SITE DEVELOPMENT PLAN
MONUMENT STEEL STRUCTURES
 BUILDING ELEVATIONS AND FLOOR PLANS
 18910 BASE CAMP ROAD
 MONUMENT, COLORADO

SHEET NUMBER
BD 1

Floor Plans_v1-redline.pdf Markup Summary

DISPLAY ZILLAH OFFICE #2

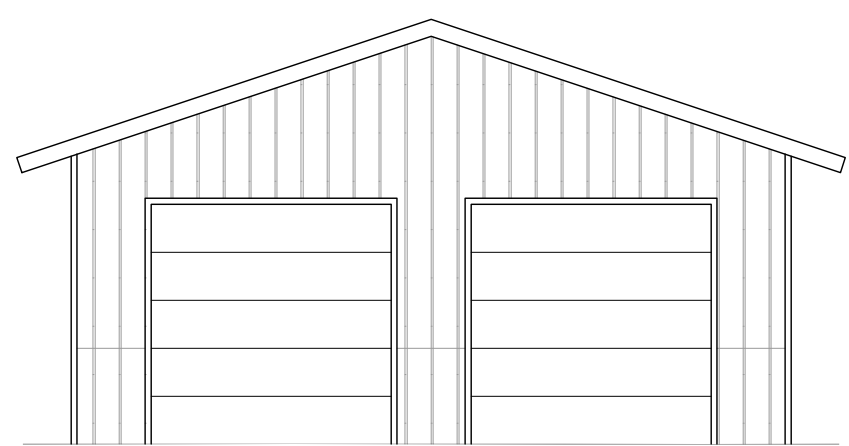
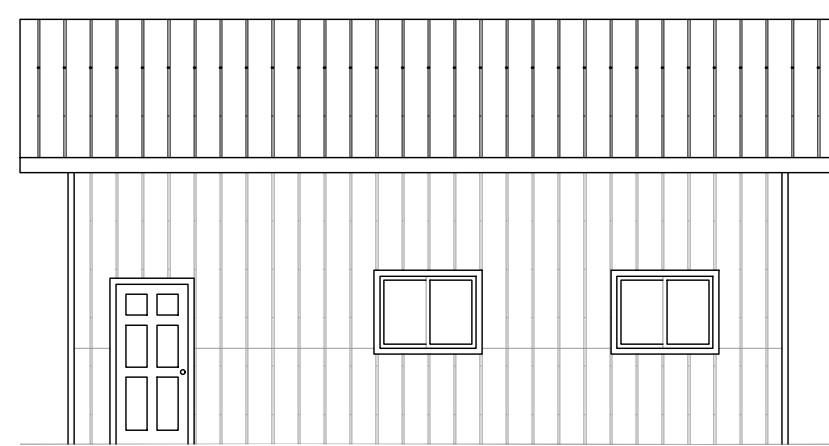
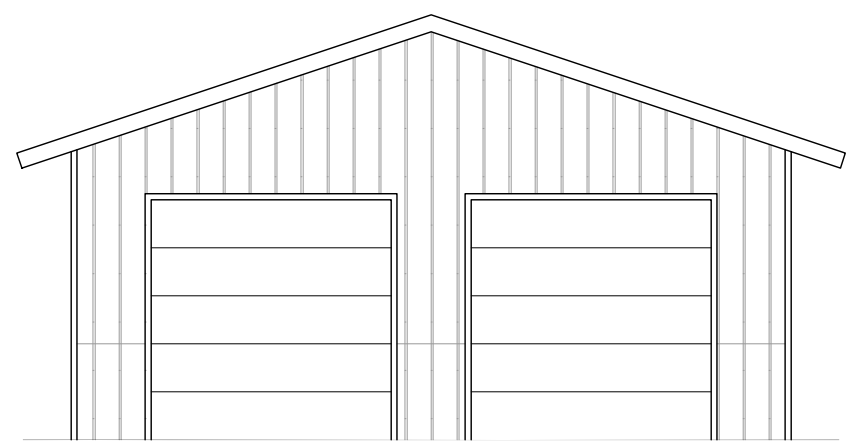
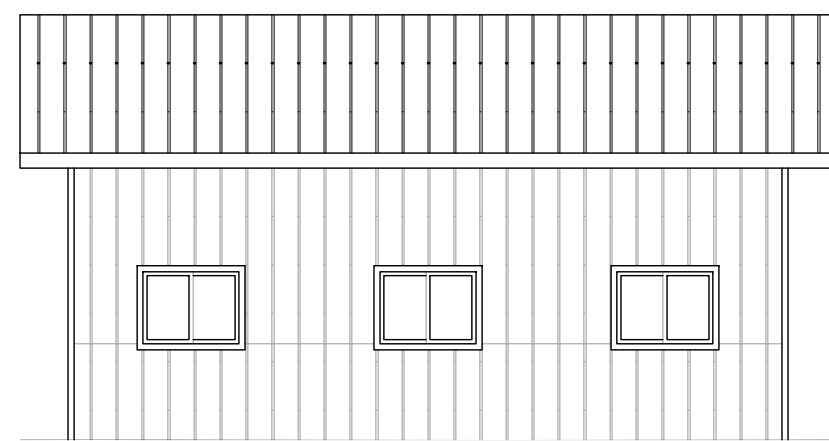
Floor plans not shown. Include dimensions
